**Addendum No 1:**  
**PROPOSED COSTCO OFFICE EXPANSION,**  
**415 WEST HUNT CLUB ROAD**  
**CITY OF OTTAWA**  
**TRANSPORTATION IMPACT**  
**ASSESSMENT REPORT** (June 20<sup>th</sup>, 2024)

The following Addendum document was produced to provide refinements to the above TIA document to account for alterations done to the Site Plan

Submitted to: Ms. Josiane Gervais  
Transportation Project Manager  
City of Ottawa  
110 Laurier Avenue  
Ottawa, Ontario K1P 1J1

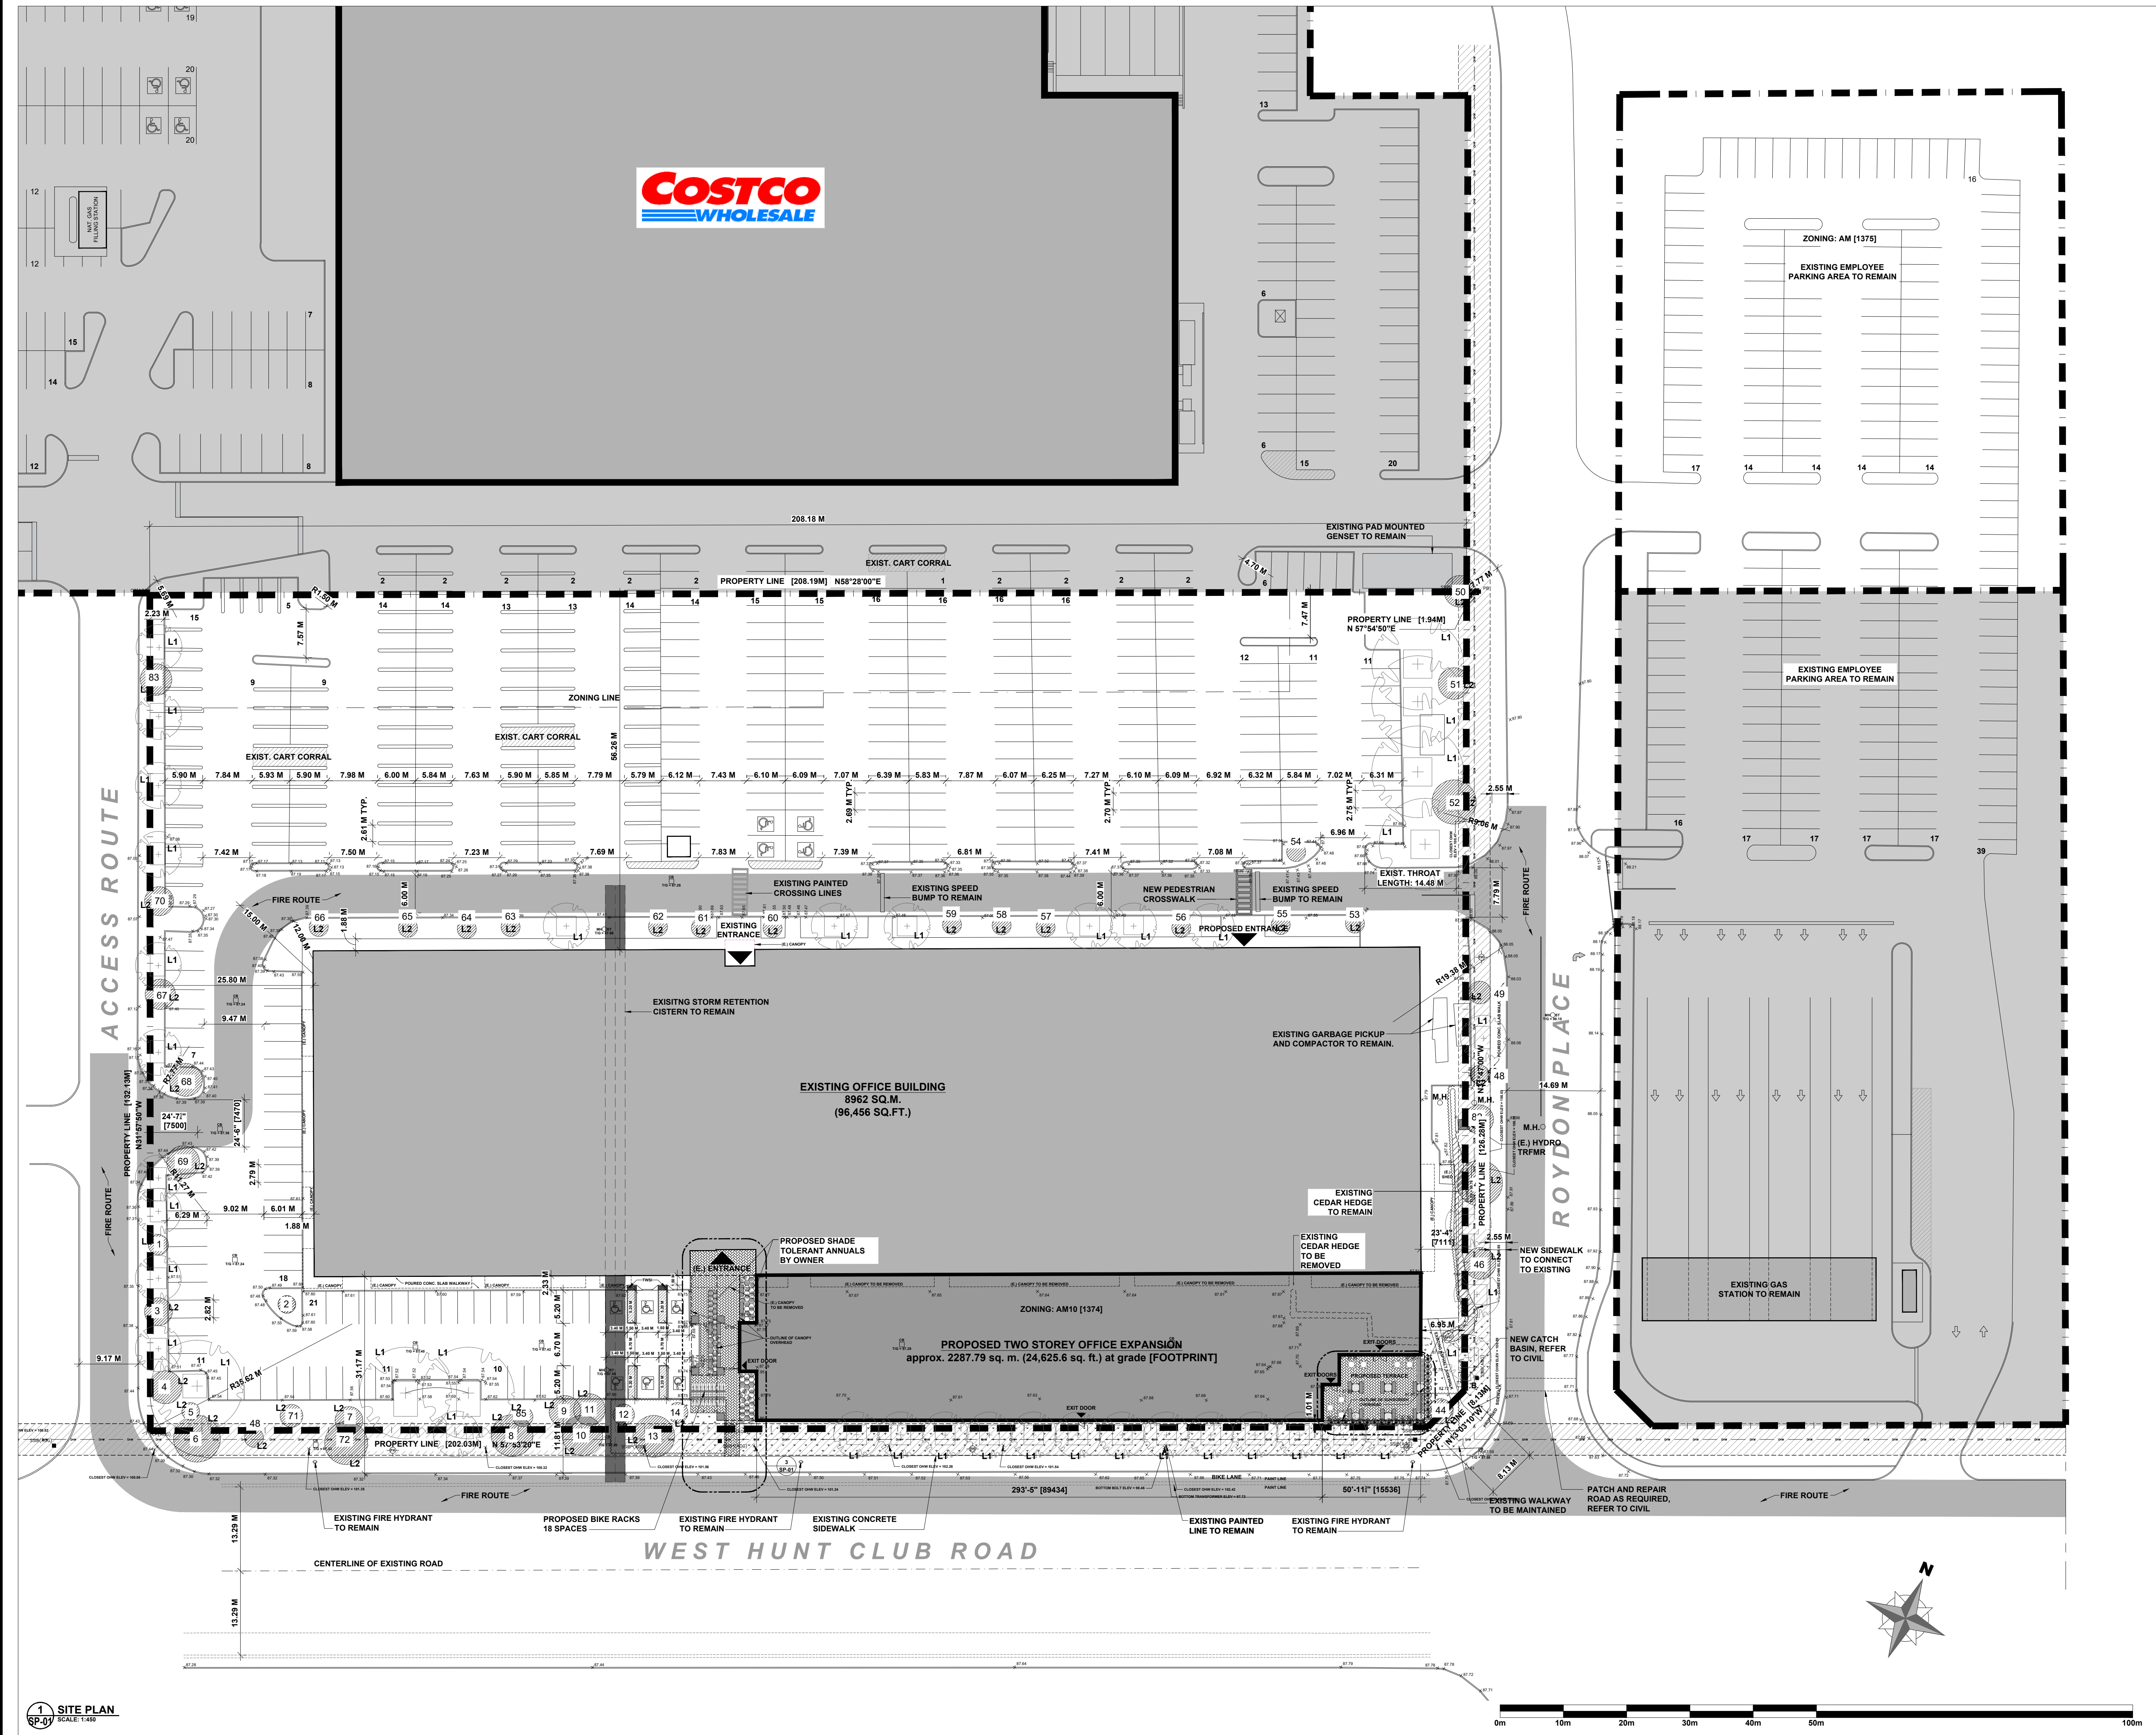
A new pedestrian link is proposed to be located on the north side of the building, across from the main employee entrance. The crossing would provide a safer delineated route for employees to cross the lane/roadway that abuts the north side of the HQ building linking the parking lot to the north of the HQ building.

## 1.4 OCCUPANCY

The project expected occupancy date has been moved from Fall of 2024 to Fall of 2025.

SP-01

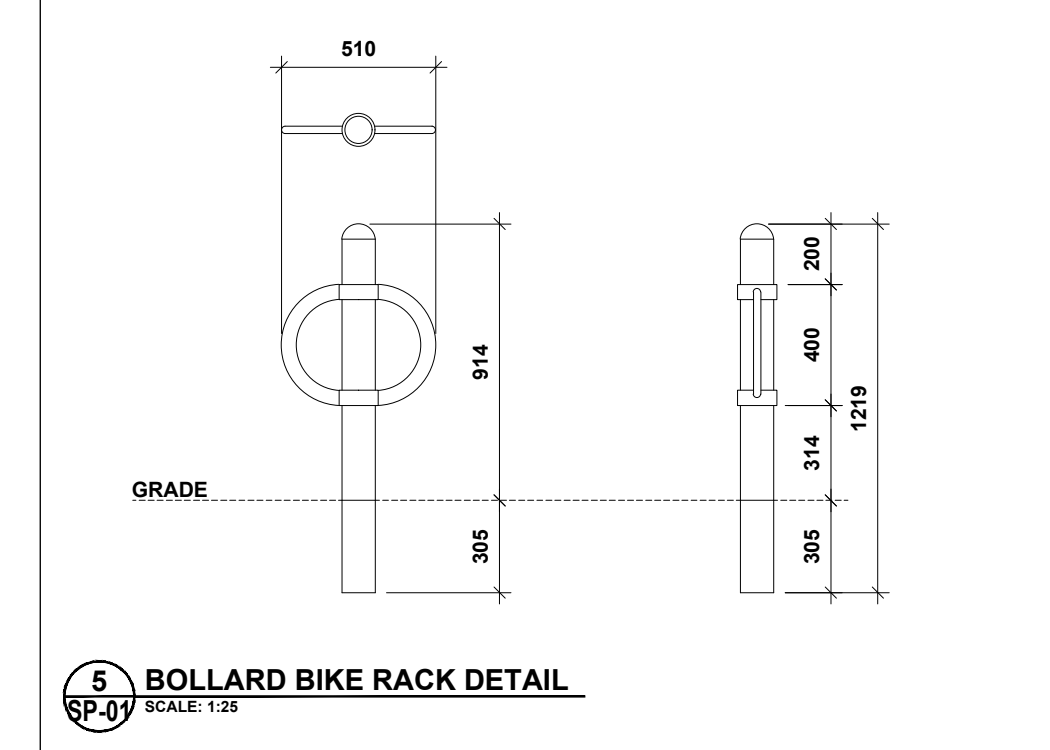
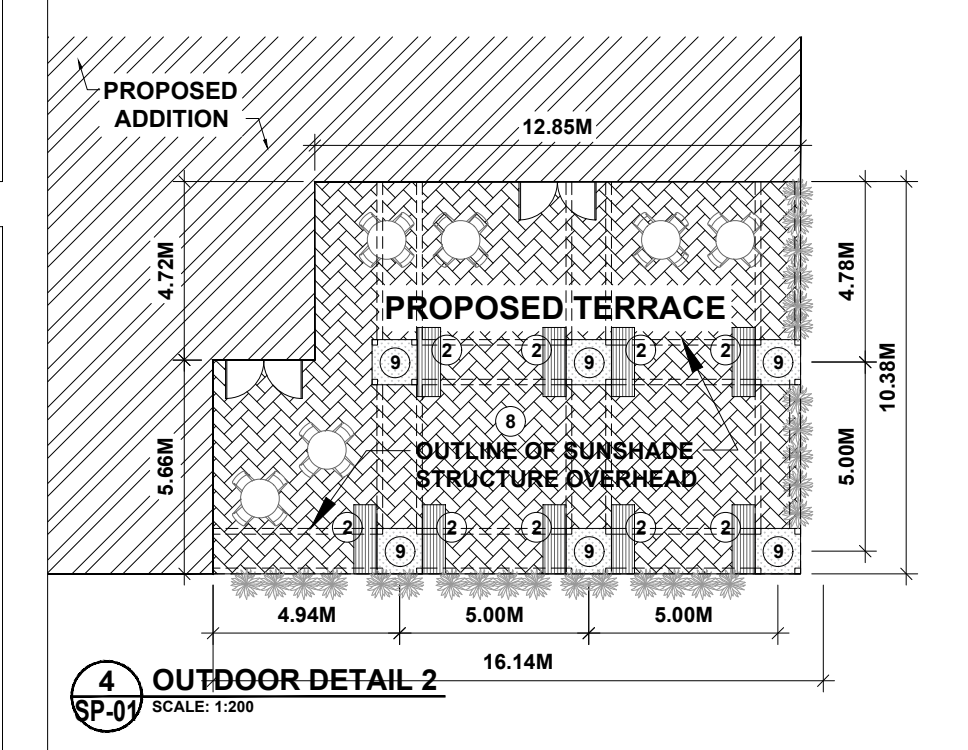
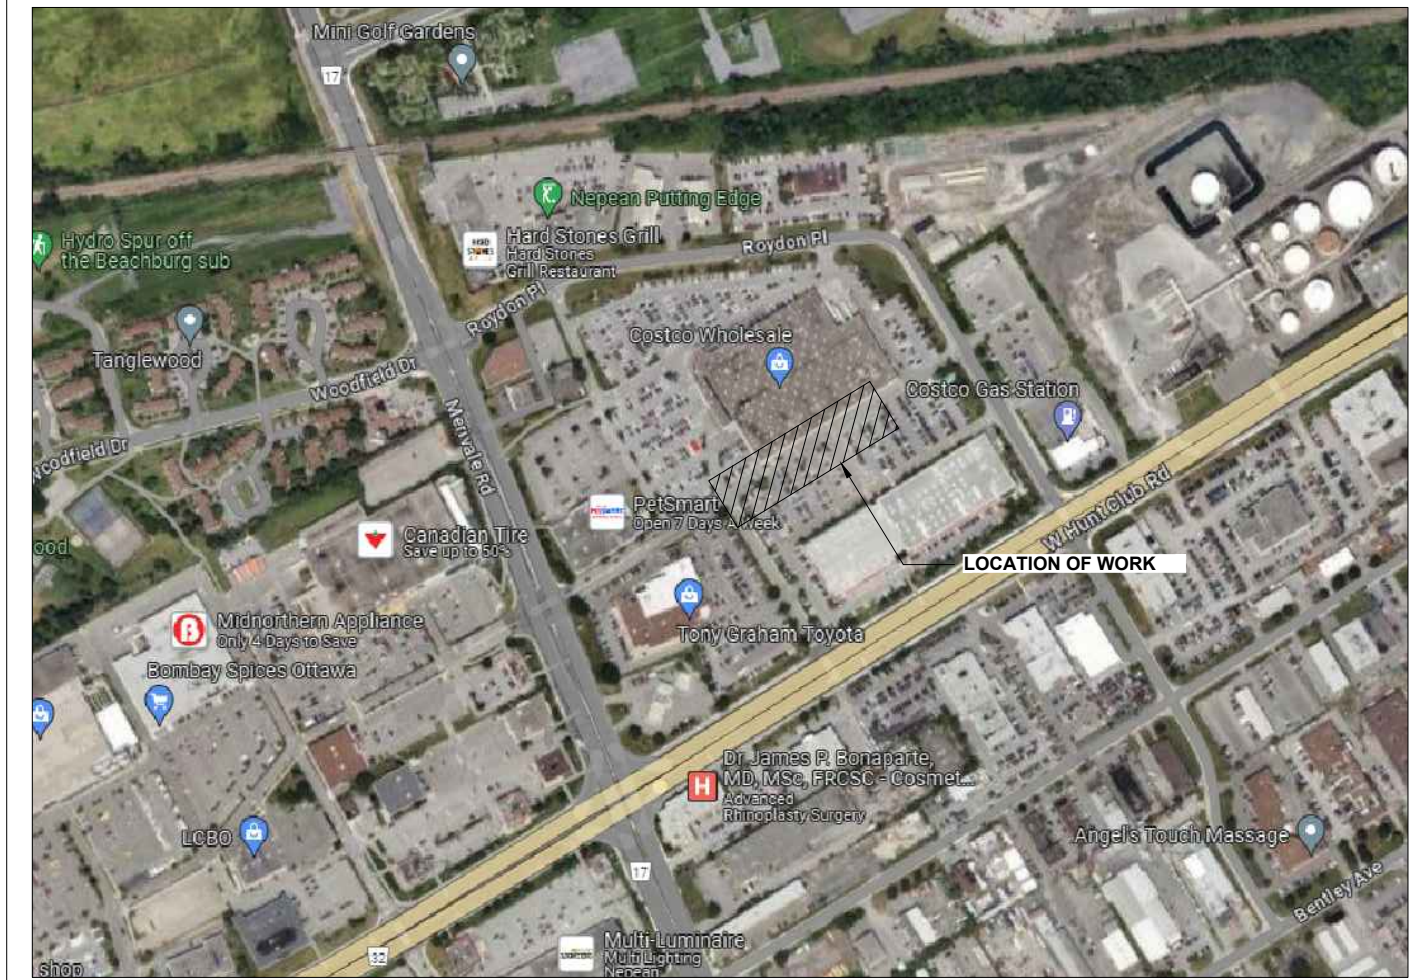
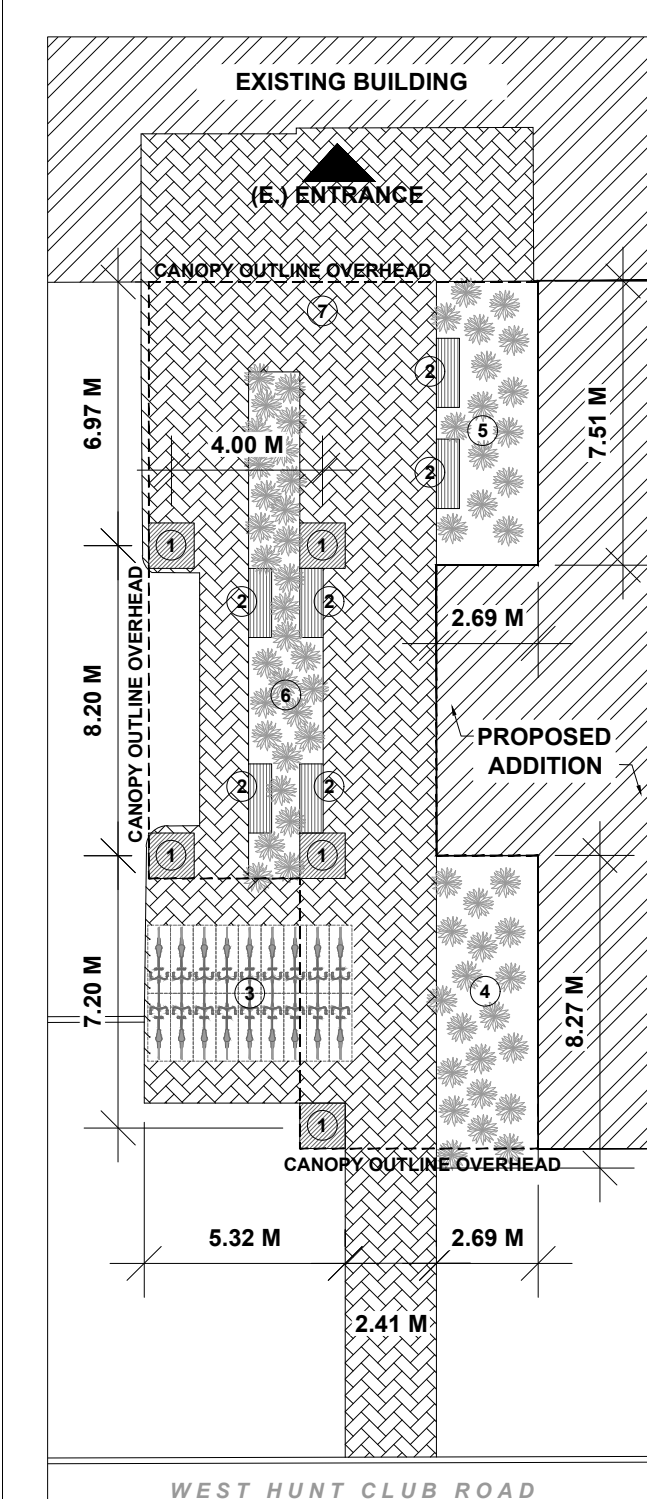
The new Site Plan dated (August 23rd, 2024) is illustrated within Annex “A”.

- The total gross floor area (GFA) of the proposed addition to the existing corporate headquarters building;
- The number of total available parking stalls;
- The location of bicycle parking;
- A new proposed pedestrian crossing at the north façade of the building; and
- The timing of occupancy.

The gross floor area (GFA) of the “proposed building addition” has decreased by approximately 19.5 percent, from 4,266.4 m<sup>2</sup> to 3,571.39 m<sup>2</sup>. In terms of the entire total building area the total GFA of the entire building decreased by 3.5% (from 12,994.4 m<sup>2</sup> to 12,533.39 m<sup>2</sup>). The change has occurred due to alterations to the permit floor plan.

The southern parking stalls were re-worked to meet AODA requirements and provide additional space for tree planting. This resulted in the provided parking stalls to decrease from 604 stalls to 602 stalls.

Table 4-2 described the bicycle parking requirements and provisions of the proposed expansion. The required parking based on the City of Ottawa parking rate has decreased from 18 bike stalls to 14 bike stalls. The site plan continues to providing 18 bike stalls, but they have been relocated from outside, west of the proposed new entrance to under a new proposed covered entrance area.
